January 13, 2015

Re: Design Progression – Final UDC
3204 Golden Copper Lane
Maple Grove Commons
Madison, WI
KBA Project #1355

Re: Letter of Intent – Final UDC Application
Maple Grove Commons
Madison, WI
KBA Project # 1355

1 THIRD FLOOR PLAN BUILDING B
A-1.3B 1/8"=1'-0"

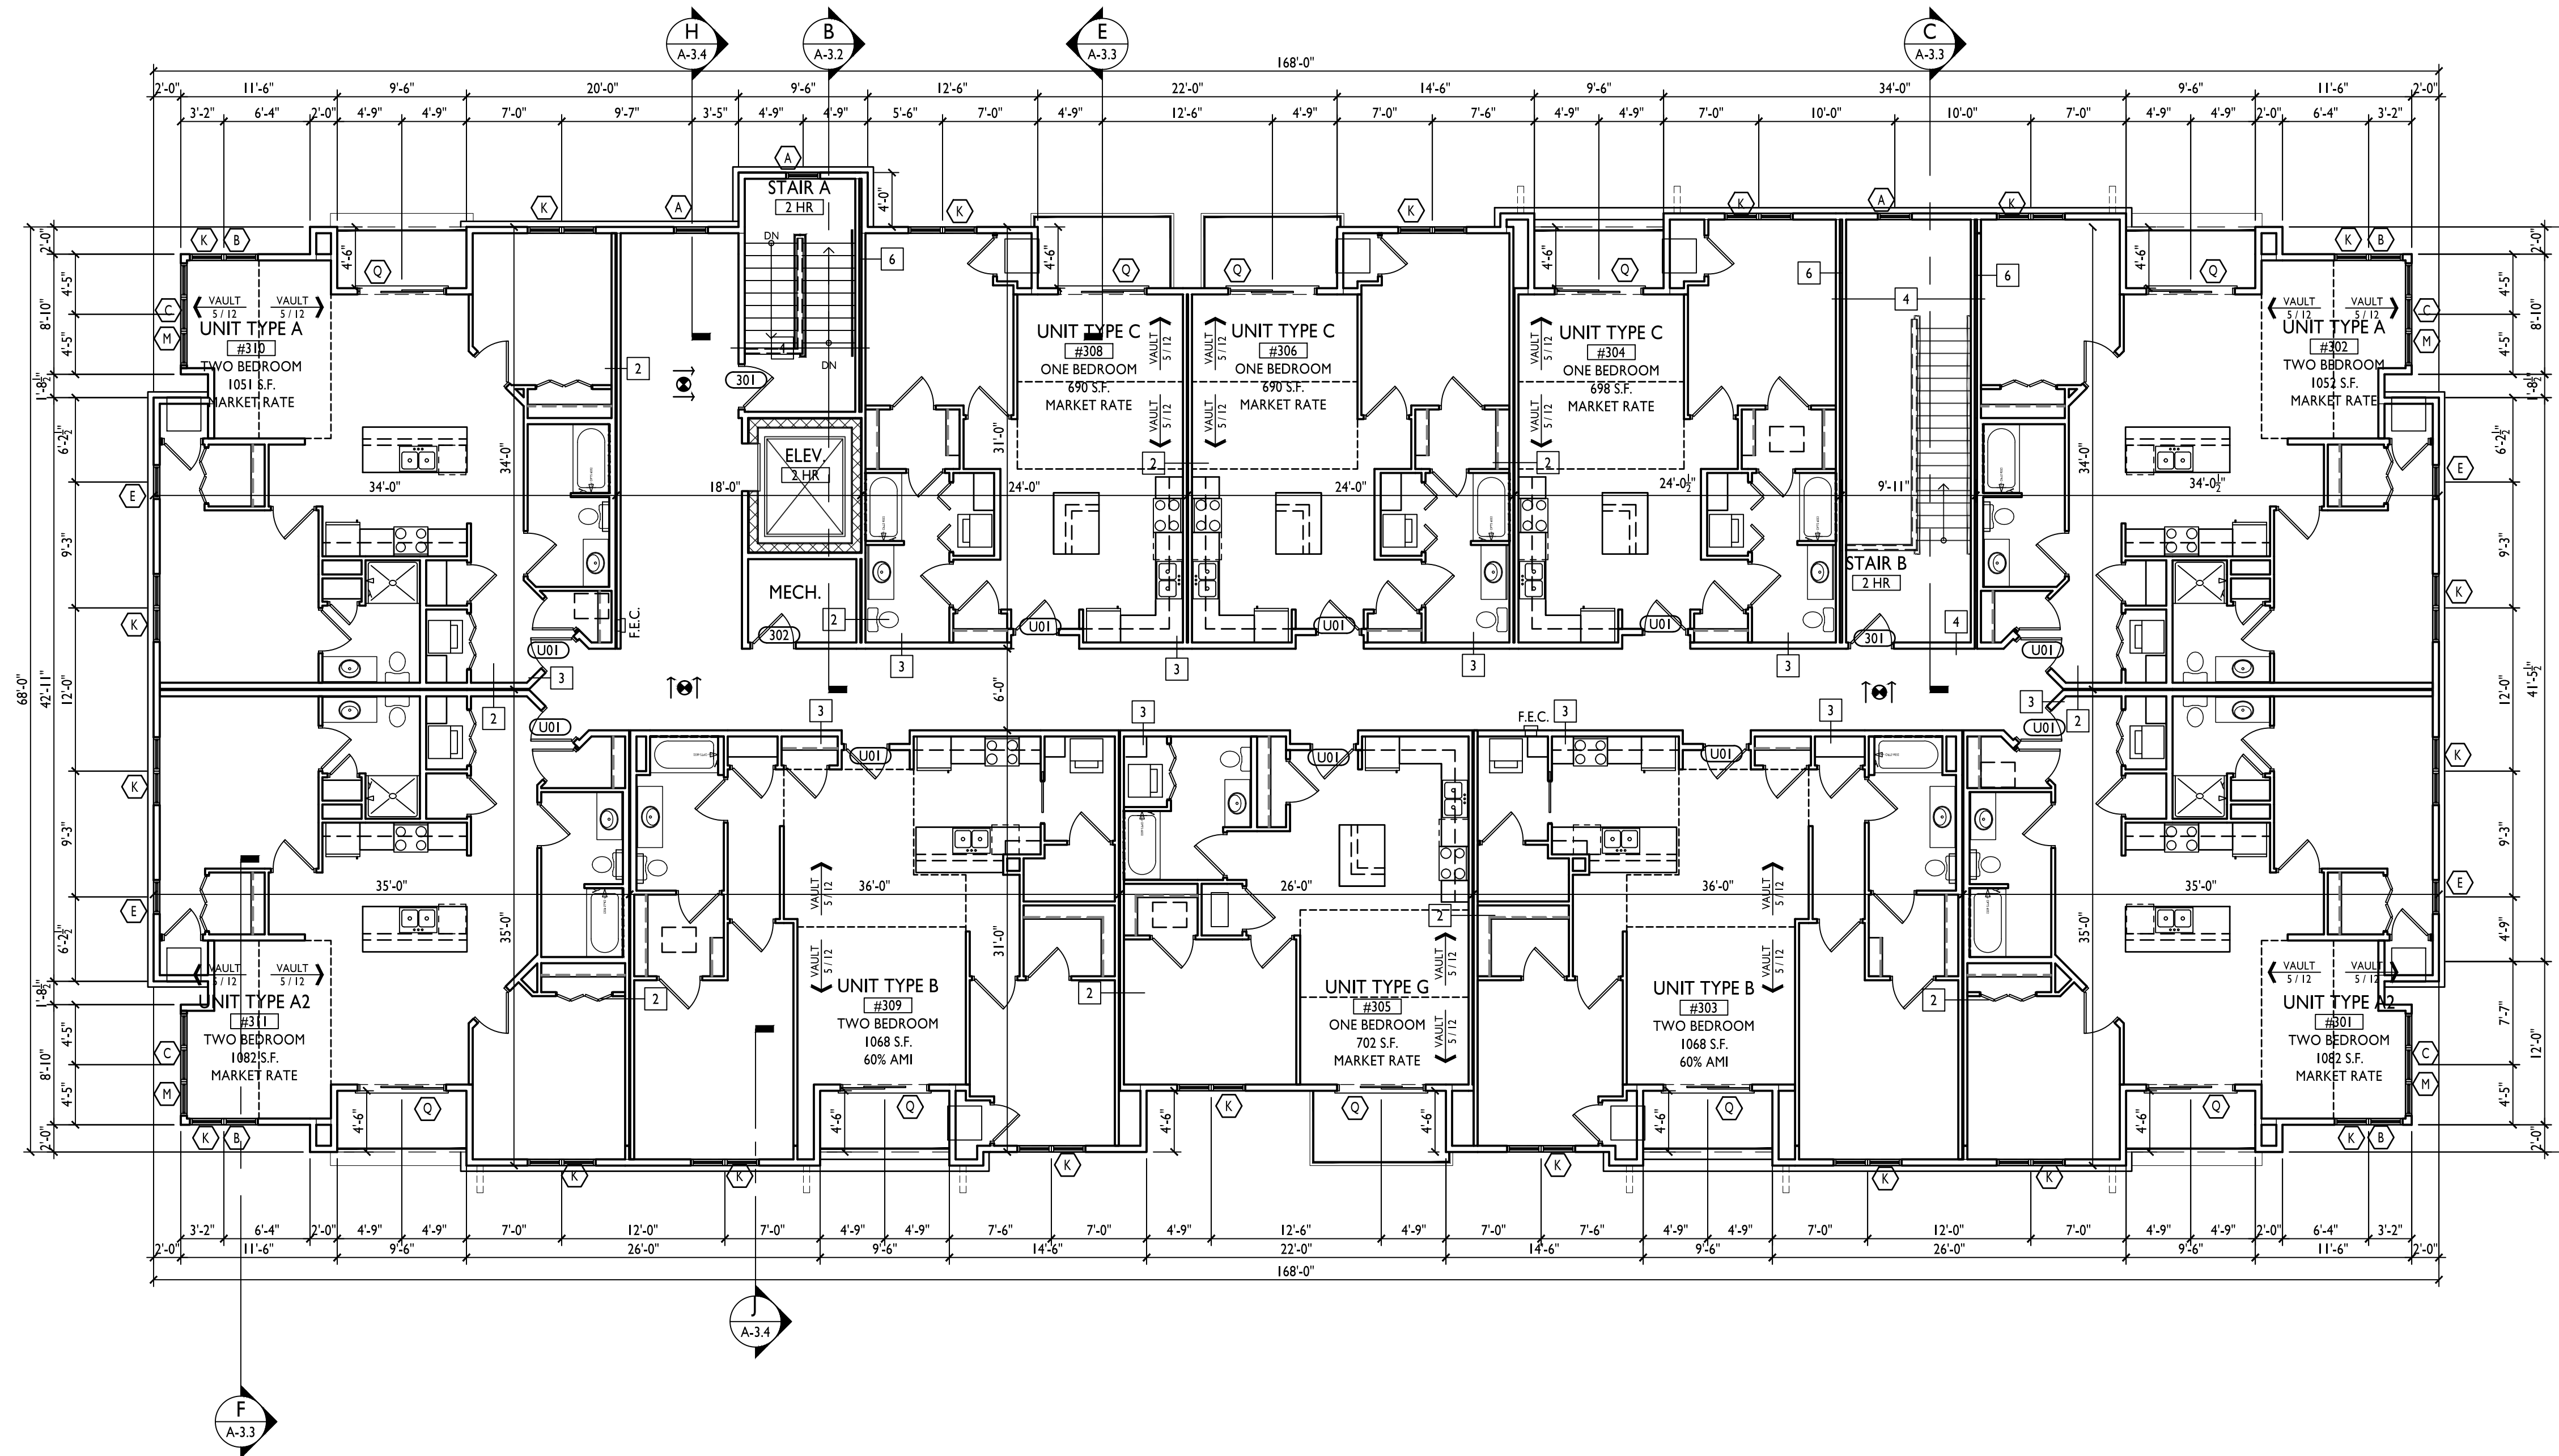
- HVAC units have been relocated in plan.

3204 & 3228 Golder Copper Ln.
Madison, WI
SHEET TITLE
Exterior Elevations - Building A

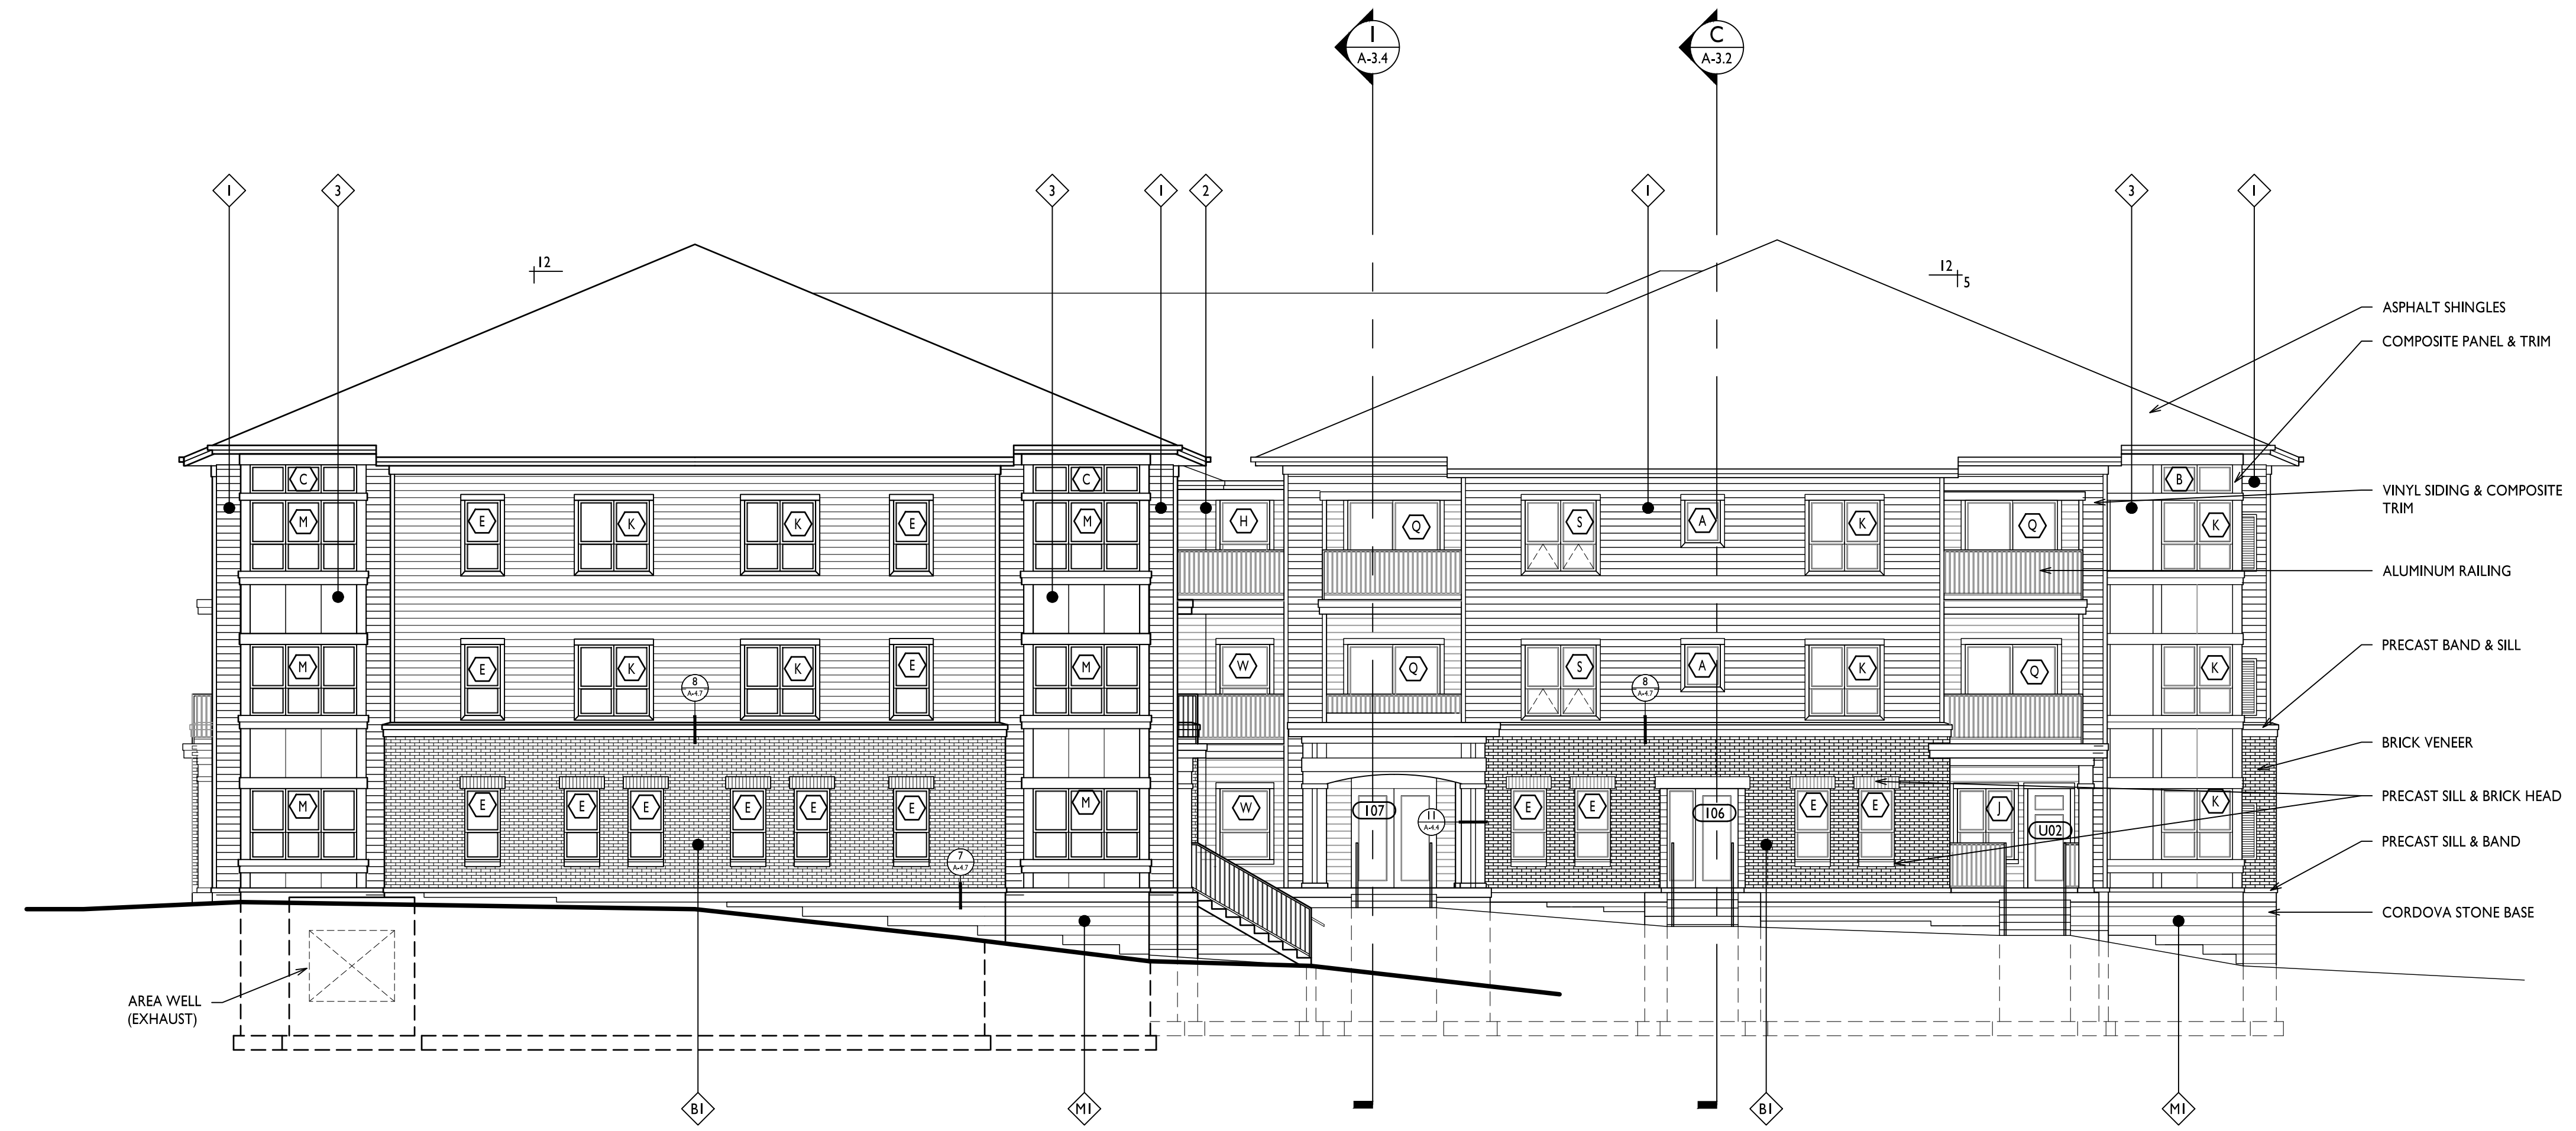
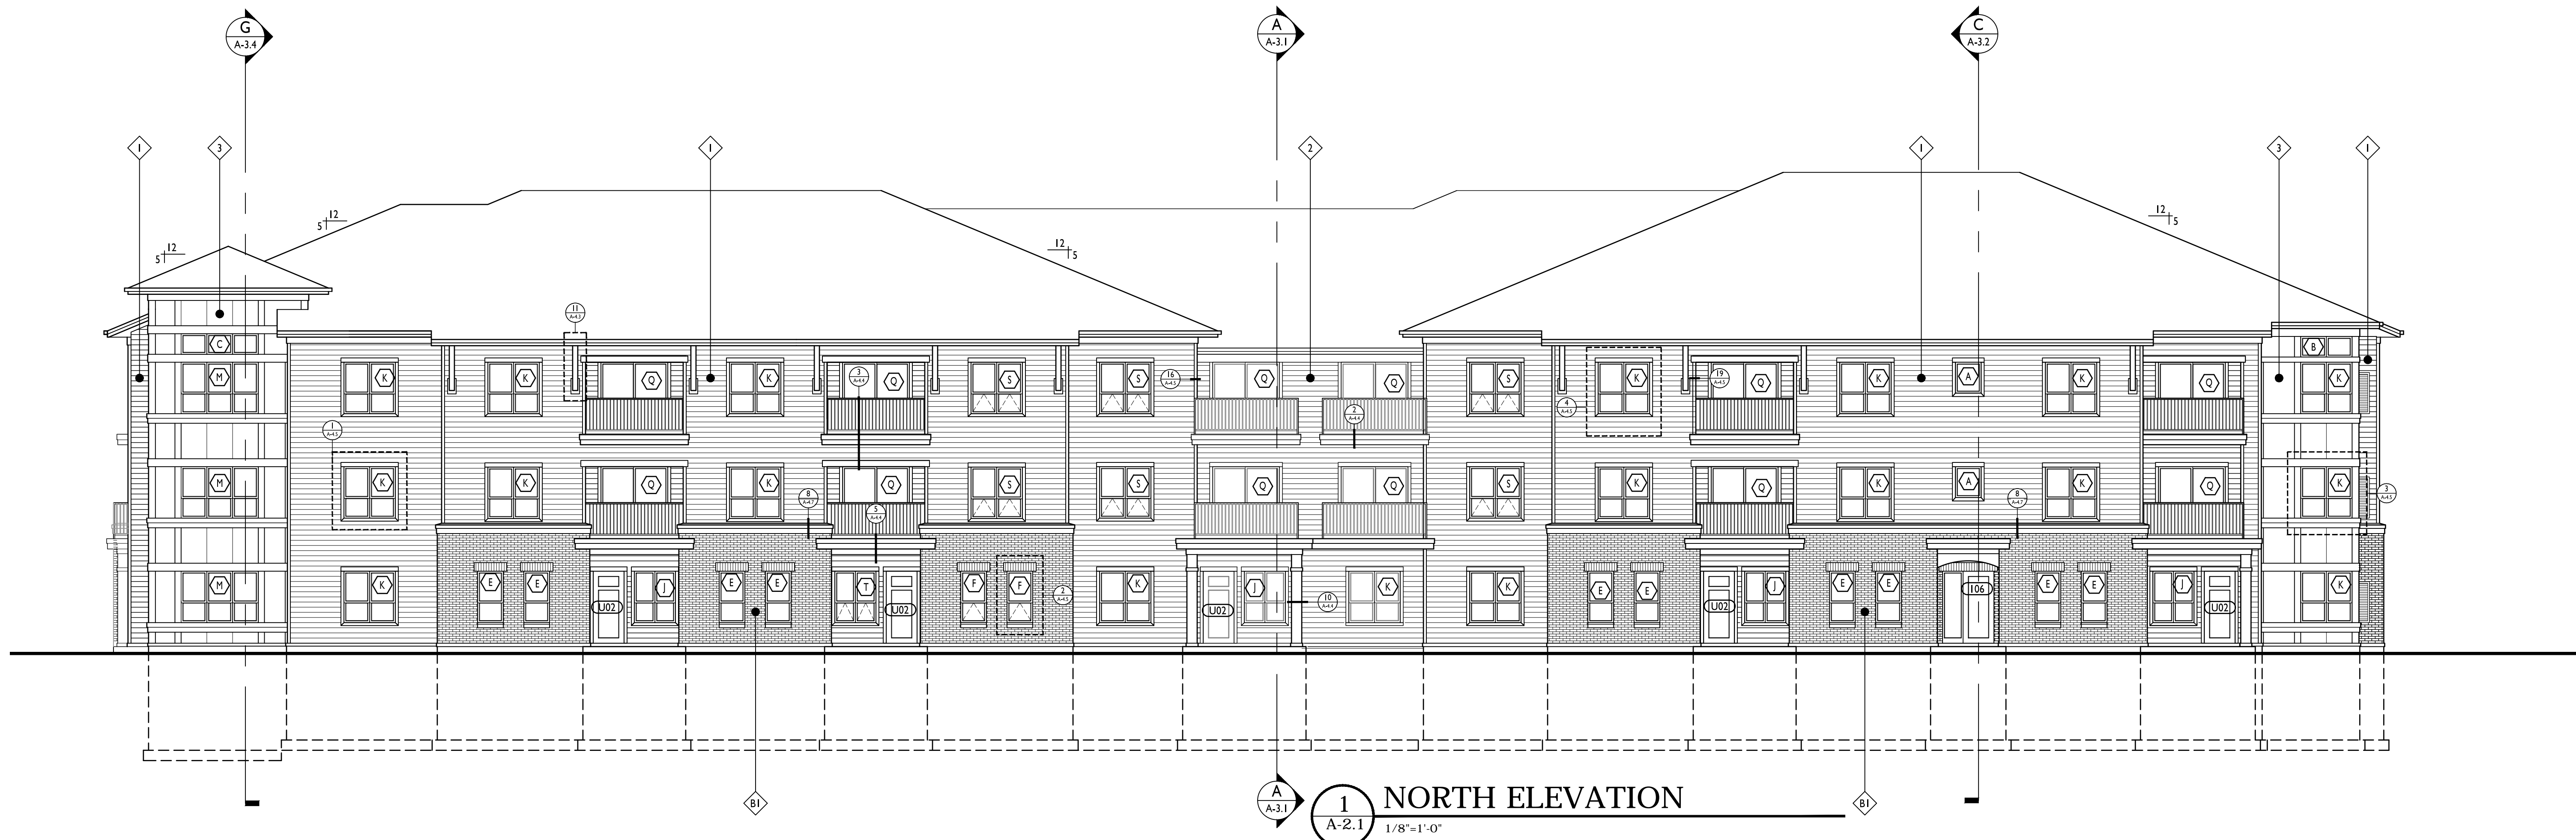
- The amount of brick veneer has been reduced.
- The concrete plaza adjacent to the community room at 3228 Golden Copper Lane has been removed (A-2.3 & A-2.4, West & South Elevation, Building B).

- Window patterns on the second floor have been modified to match the window patterns on the third floor.
- The balcony railings have been modified from a double top rail with vertical pickets to a single top rail with vertical pickets.
- Roof overhangs have been reduced from 36" to 24".
- Four of the first floor patio doors have been replaced with sliding patio doors (A-2.3, North Elevation, Building B)
- The quad windows on the corner bay have been modified to tripe windows on the North & East elevations of Building A.
- All composite arch trim above the first floor patios was removed except at the main building entries.
- The HVAC penetrations at the new locations are shown.
